RESEARCH REACTOR CENTER

Reference: Docket 50-186
University of Missouri-Columbia Research Reactor
Amended Facility License R-103

SUBJECT: Written communication as specified by 10 CFR 50.4(b)(1) regarding the response to the
“University of Missouri at Columbia – Request for Additional Information Re: License
Renewal, National Historic Preservation Act (TAC No. MD3034),” dated April 30, 2010

ATTACHMENT 8

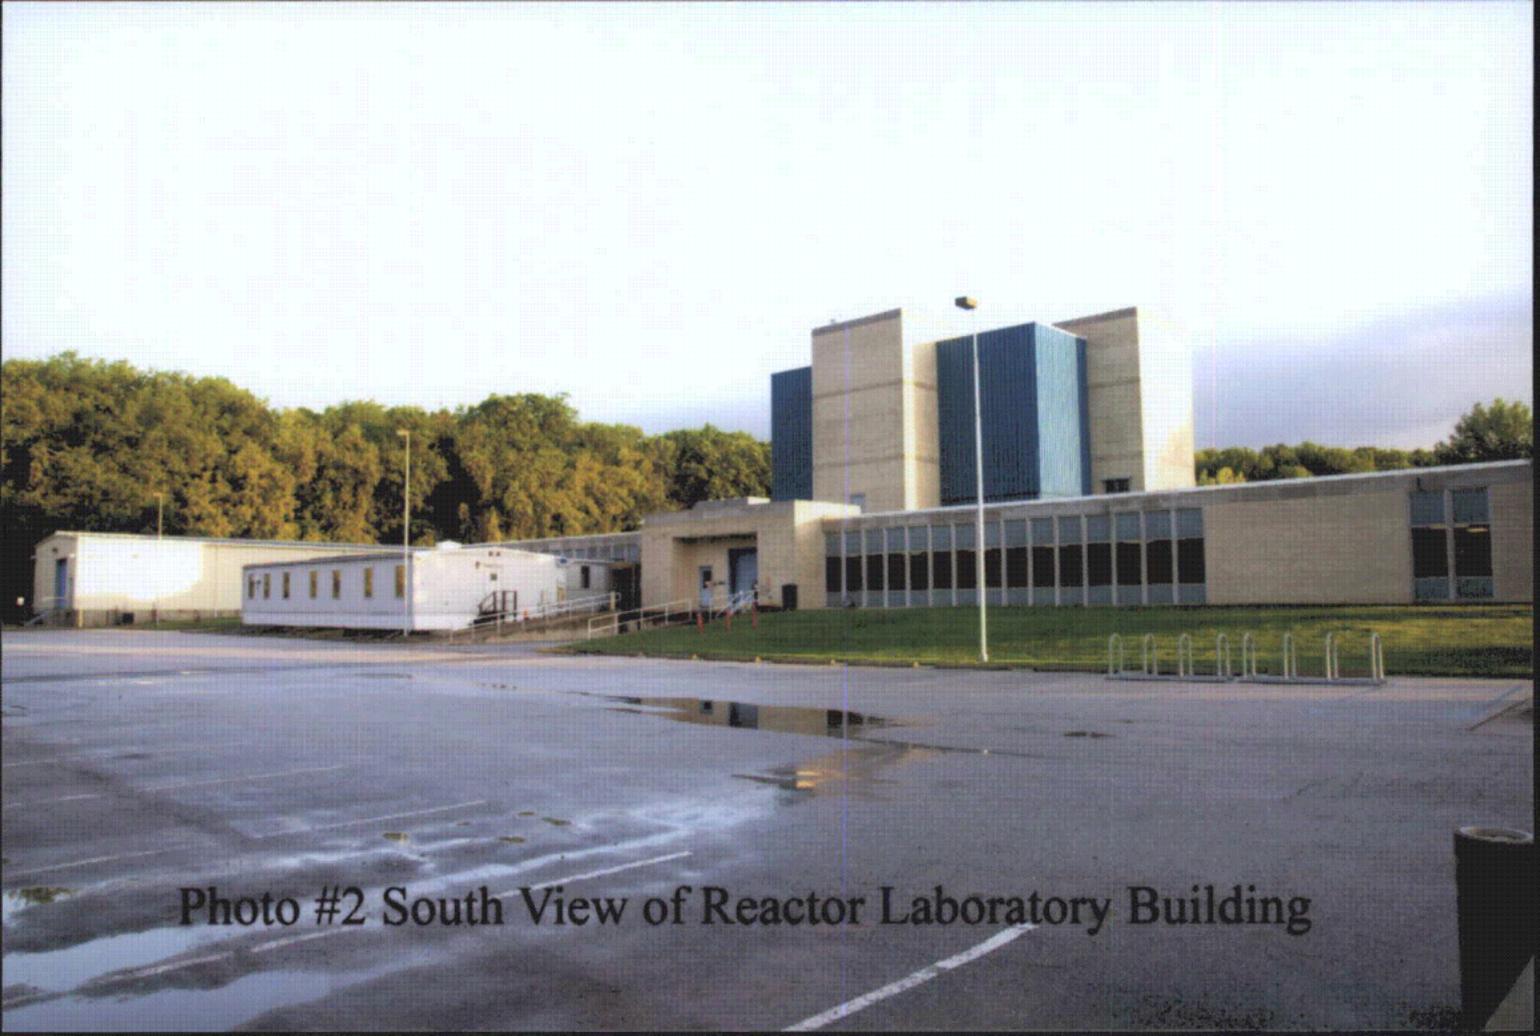
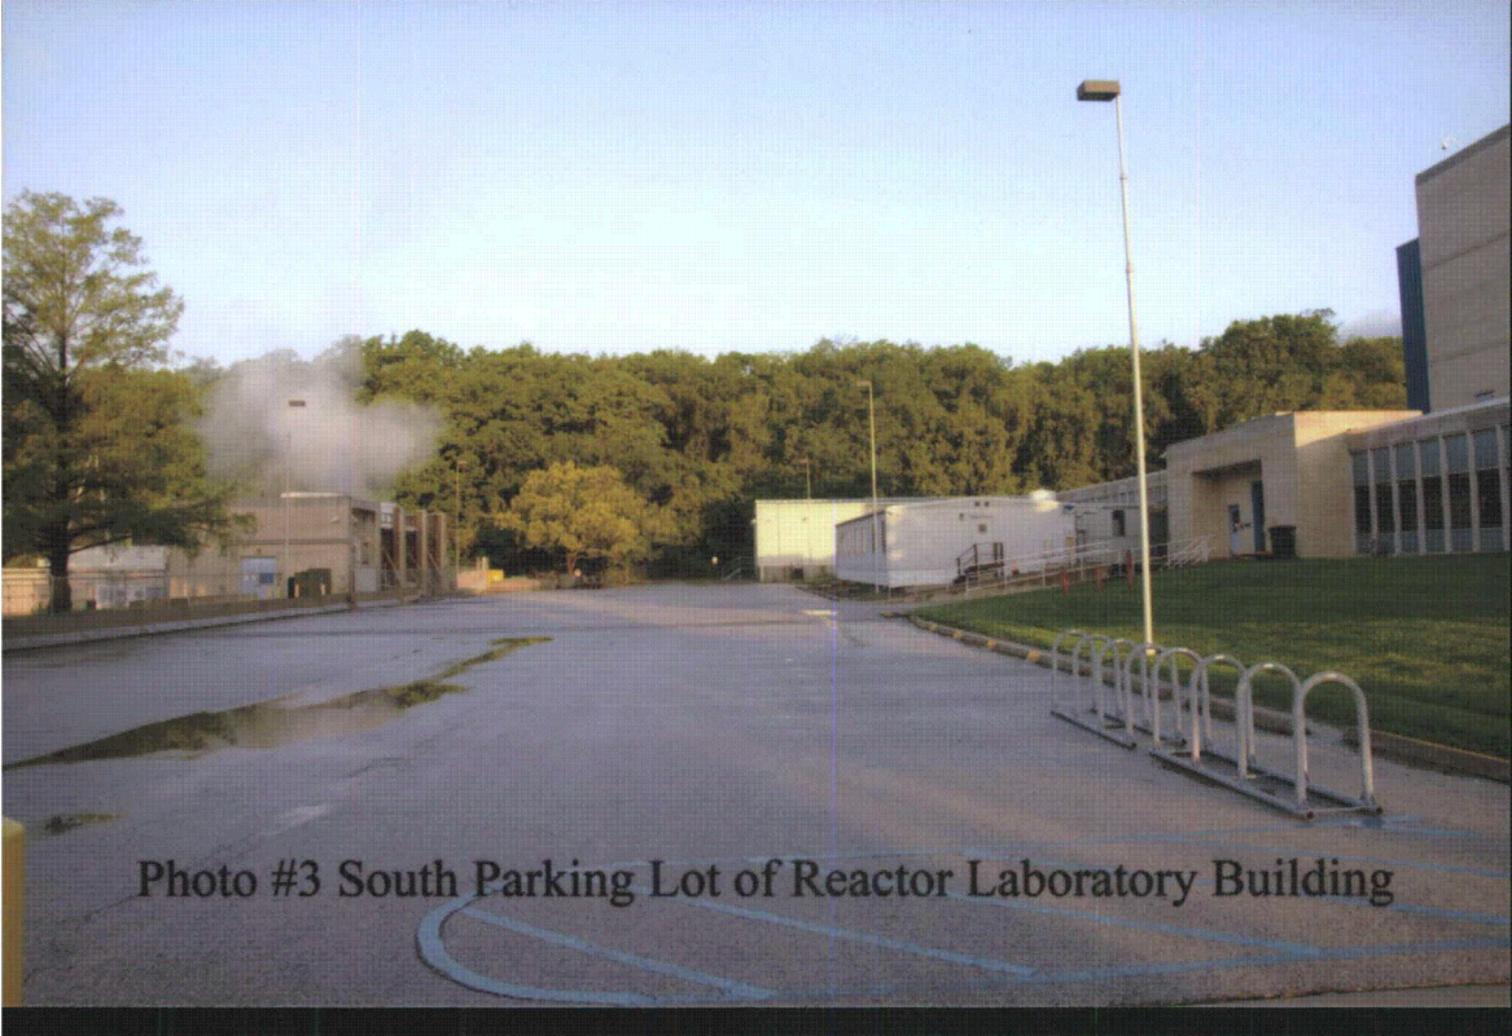
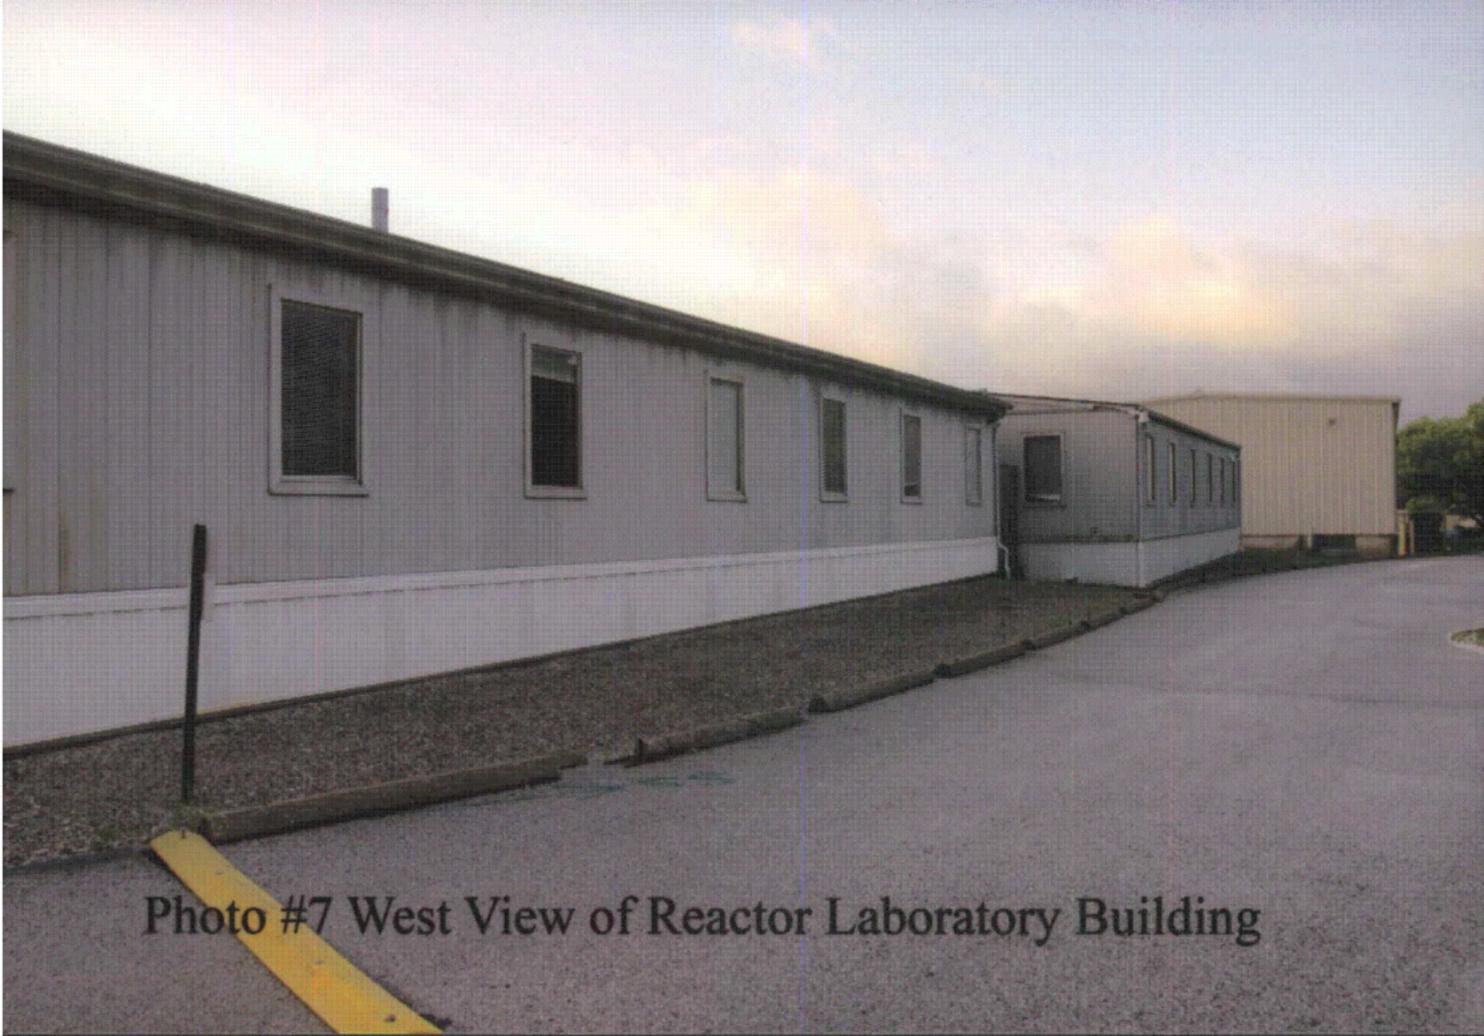
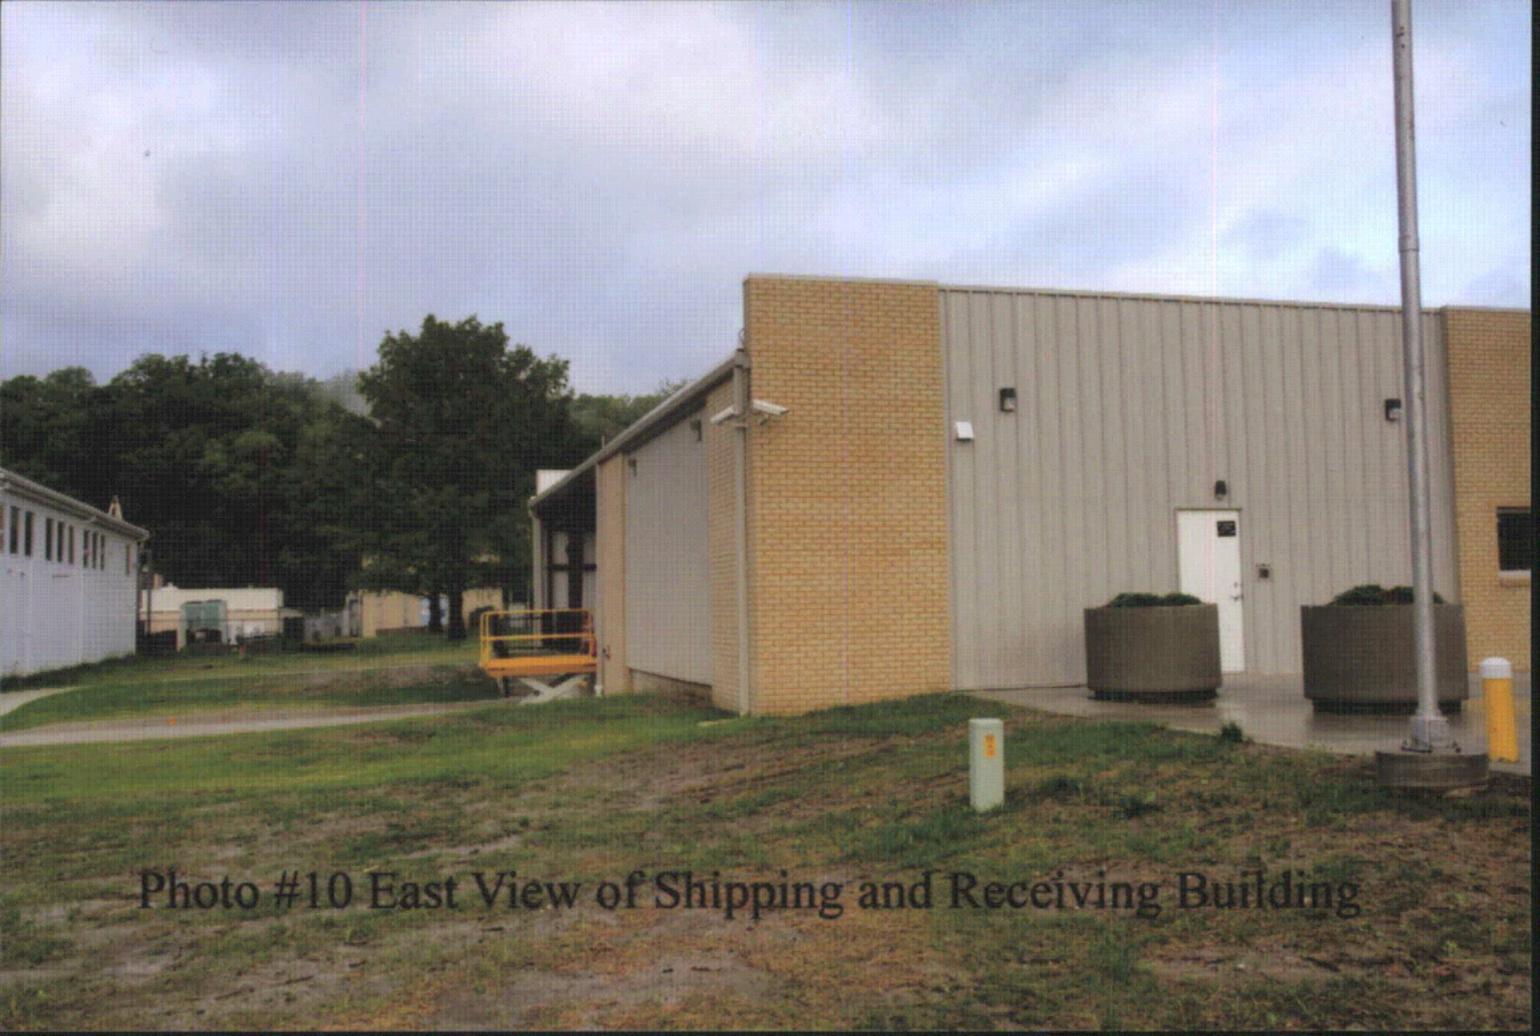
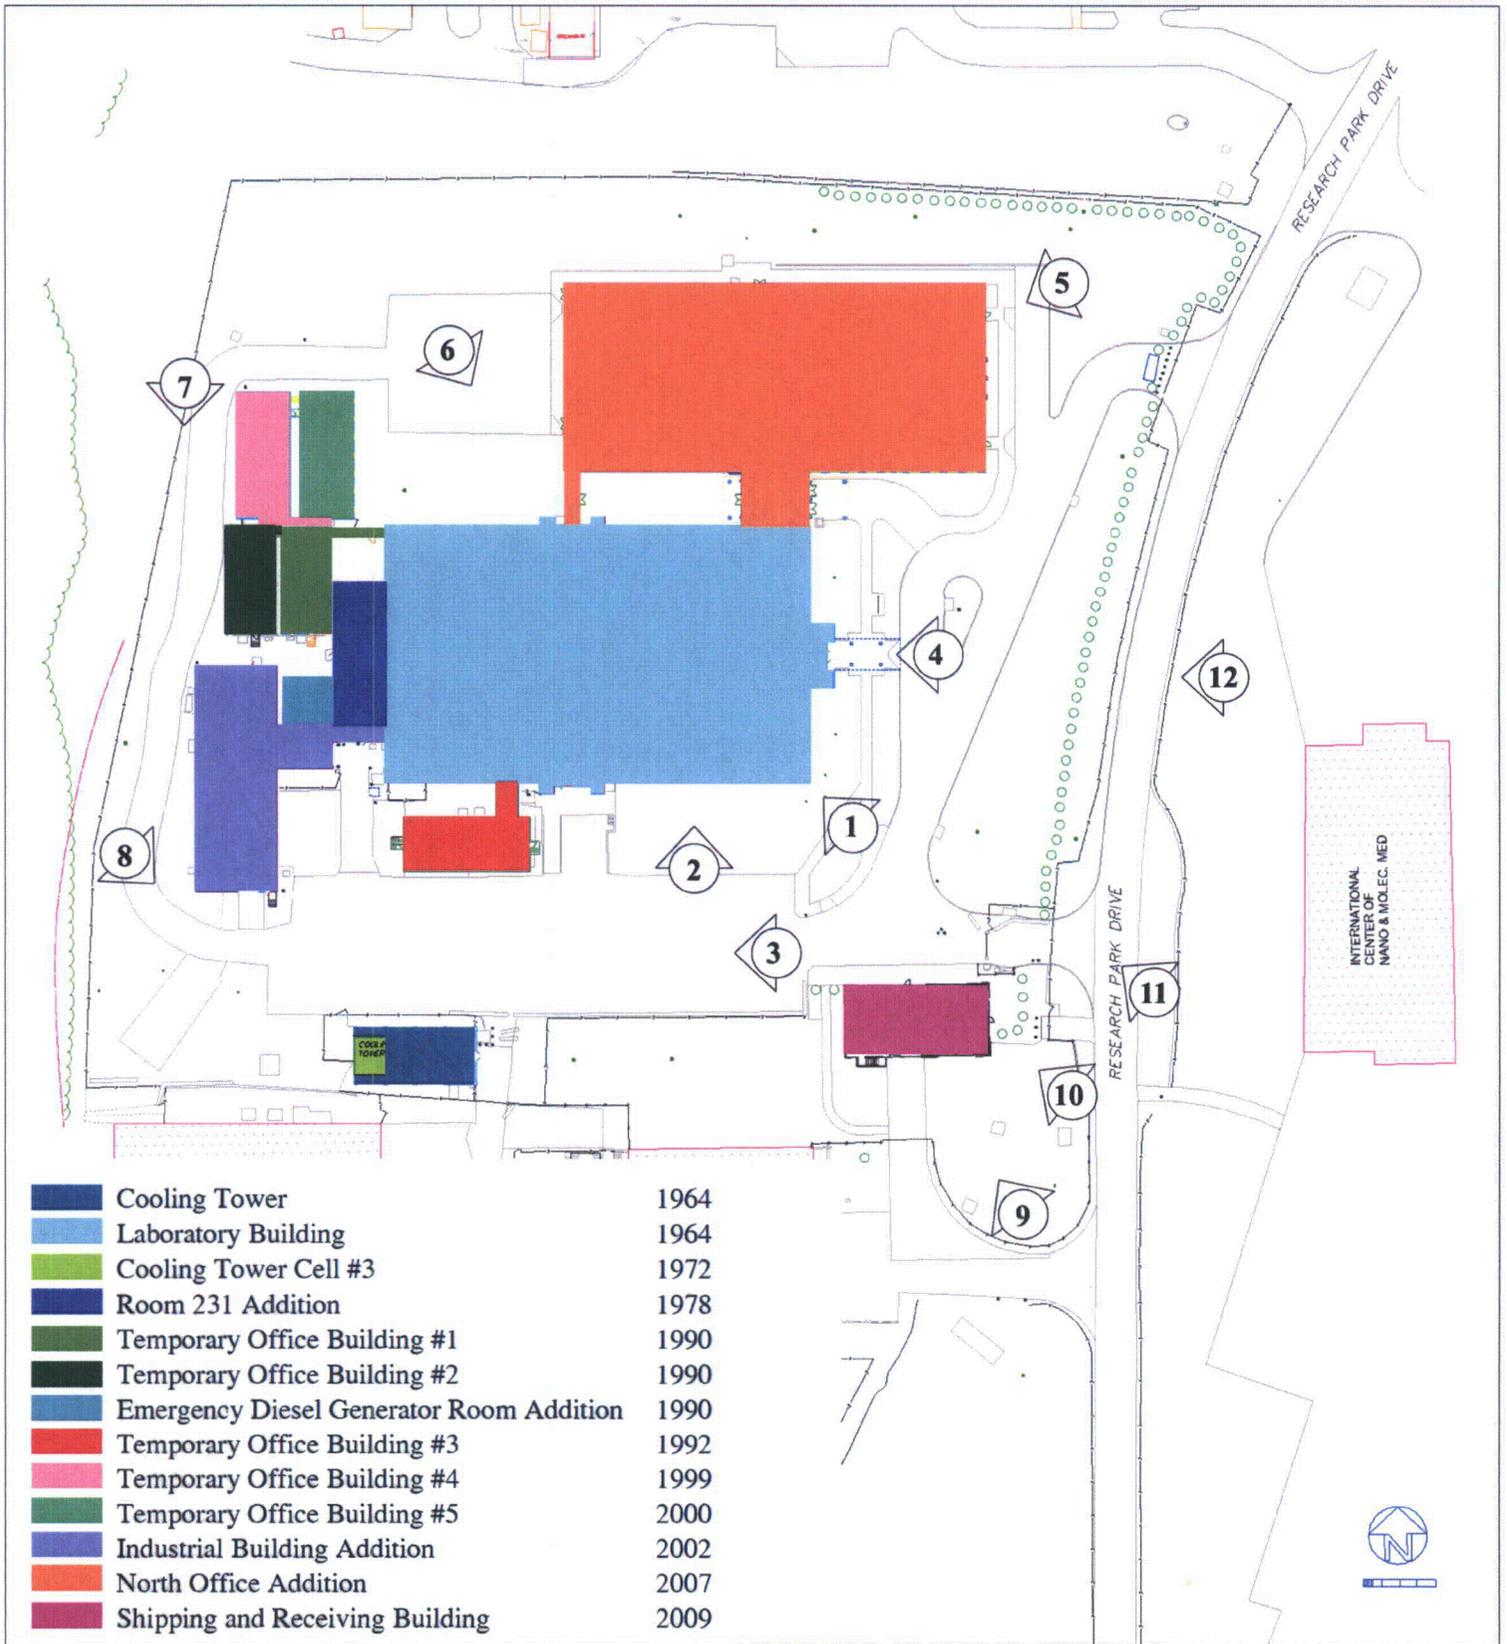
5. *Please provide photographs of all structures. All photographs should be labeled and keyed to one map of the project area. Photographs must be clear black and white or color photographs on photographic paper, of minimum 3" x 5" size. Polaroid's, photocopies, emailed, or faxed photographs are not acceptable. Photographs of neighboring or nearby buildings are also helpful and should be labeled and keyed to one map of the project area.*

Attached are twelve (12) 4" x 6" color photographs (Attachment 8) of all of the MURR site structures. The photos are labeled and keyed to the attached map of the MURR site (Attachment 9). Arrows on the map depict the directions that the photographs were taken.
